East Anglia ONE North and East Anglia TWO Offshore Windfarms

Deadline 7 Project Update Note

Applicants: East Anglia ONE North Limited and East Anglia TWO Limited
Document Reference: ExA.AS-17.D7.V1
SPR Reference: EA1N_EA2-DWF-ENV-REP-IBR-001332 Rev 01

Appendix 1 – Figure 1: Reduction of Order Limits at Work No. 6 Boundary

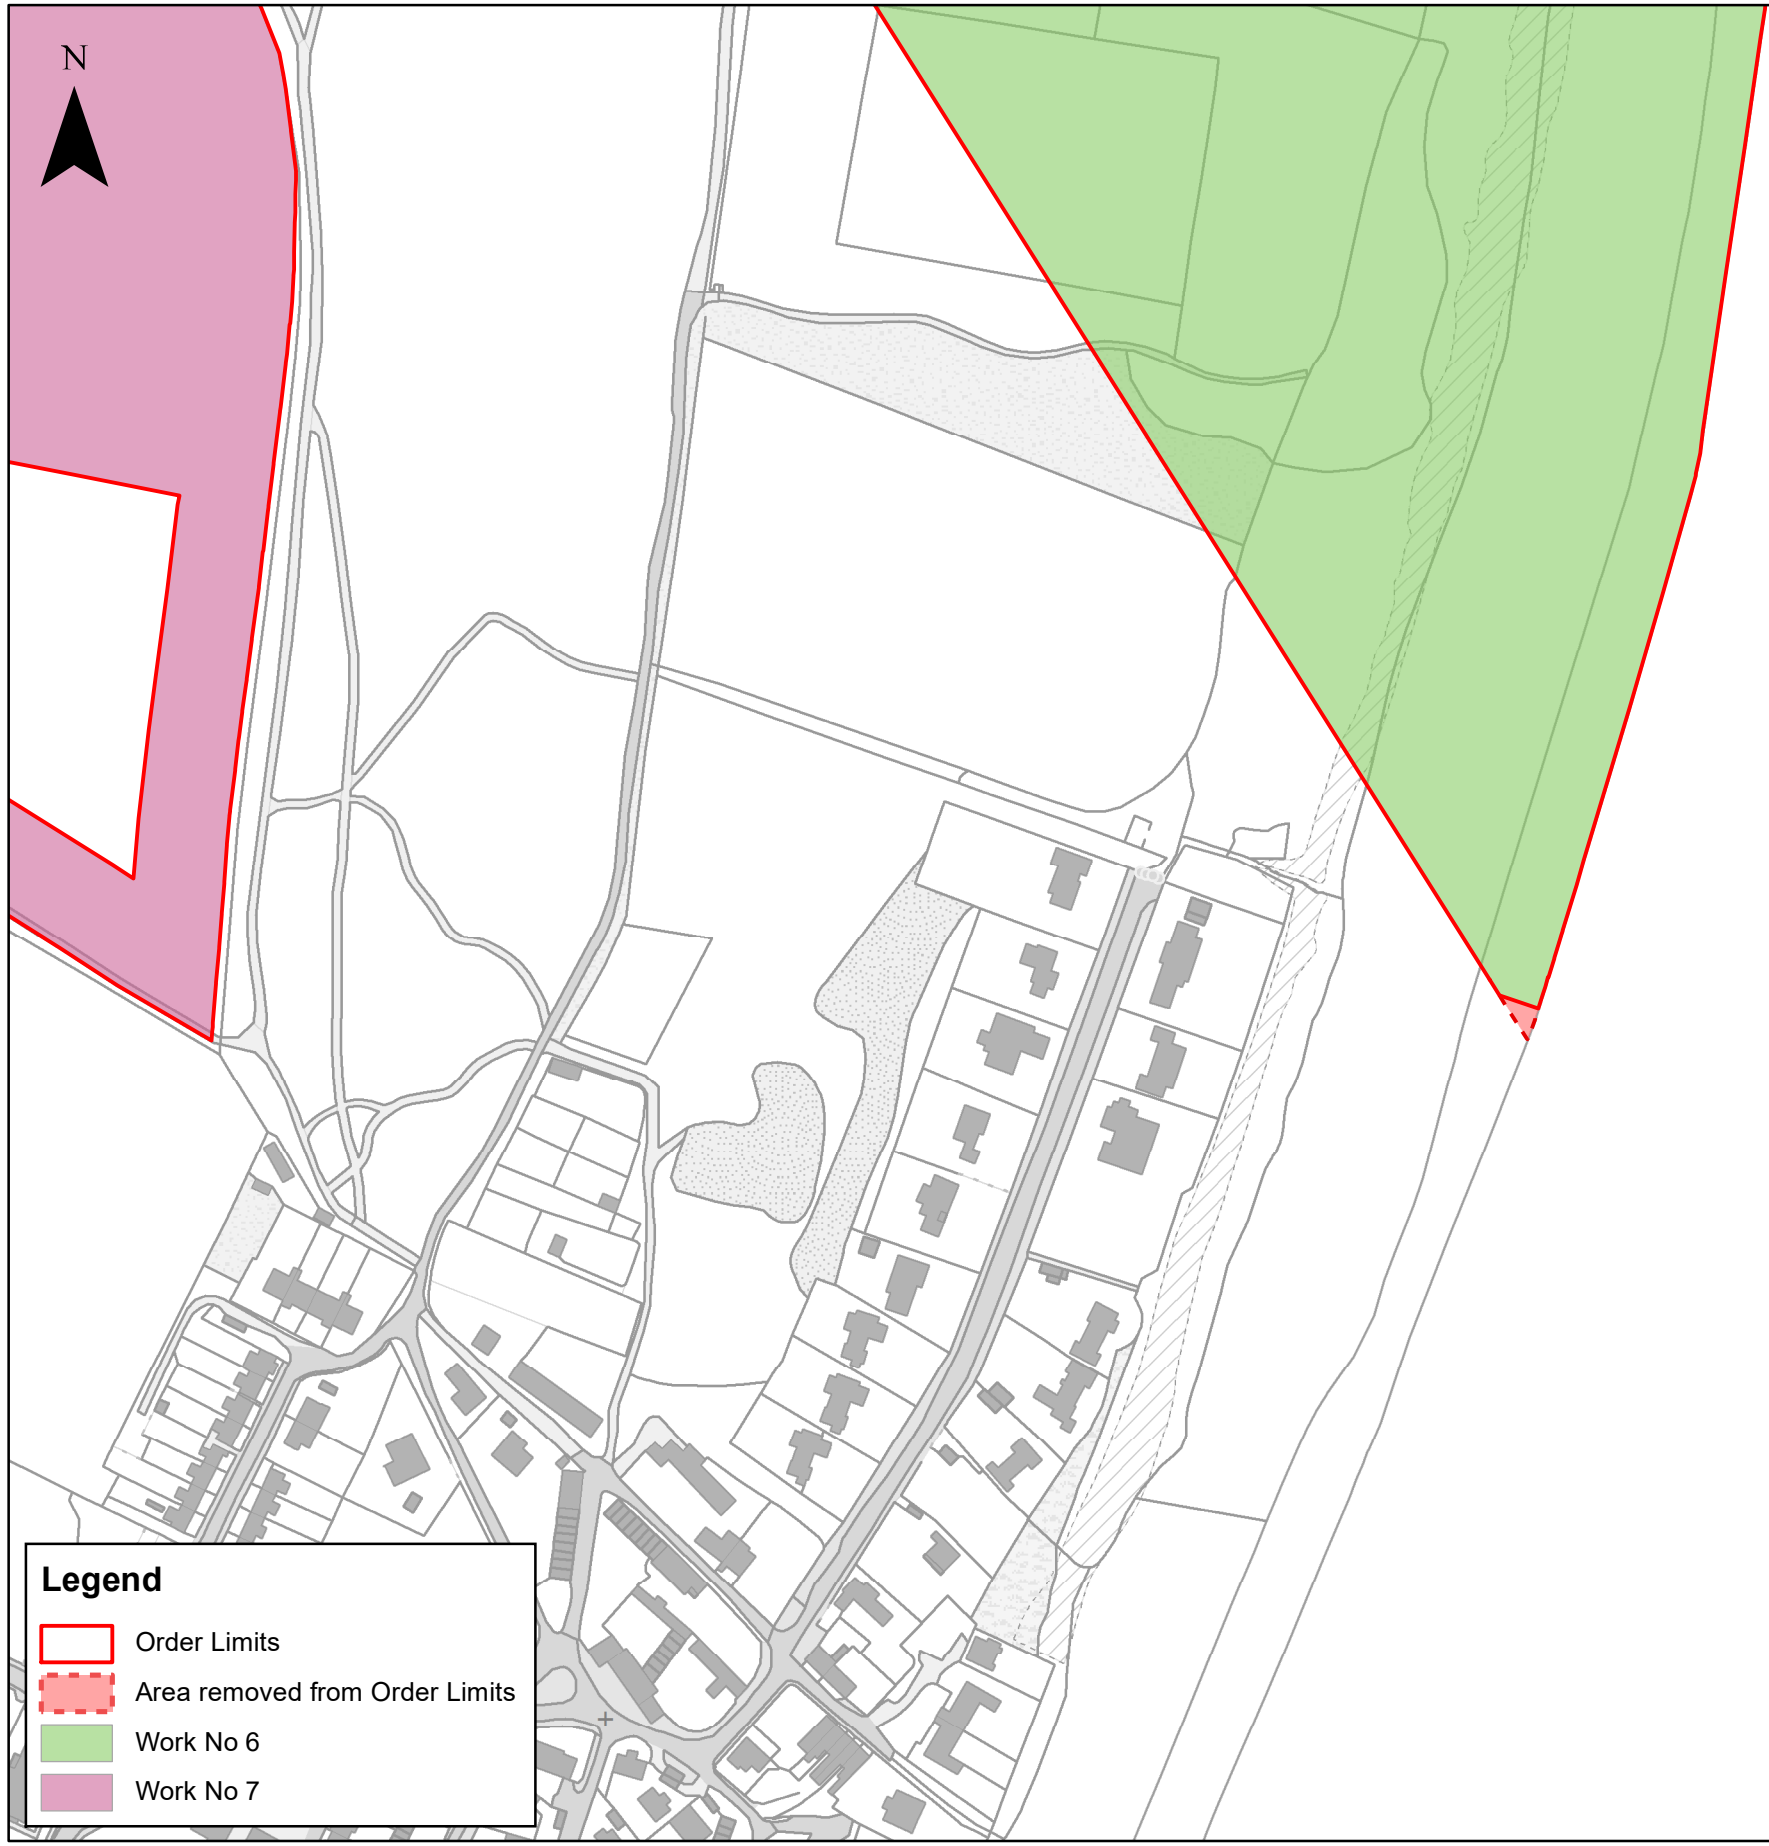
4. The Applicants have amended the Projects' Order limits at Work No. 6 (landfall), removing plot 3 (shown in **Land Plans Onshore** (REP1-004)) at the request of East Suffolk Council. Removal of plot 3 has removed approximately 75m² from the Projects' Order limits. Figure 1 (Appendix 1) shows the extent of this non-material change.
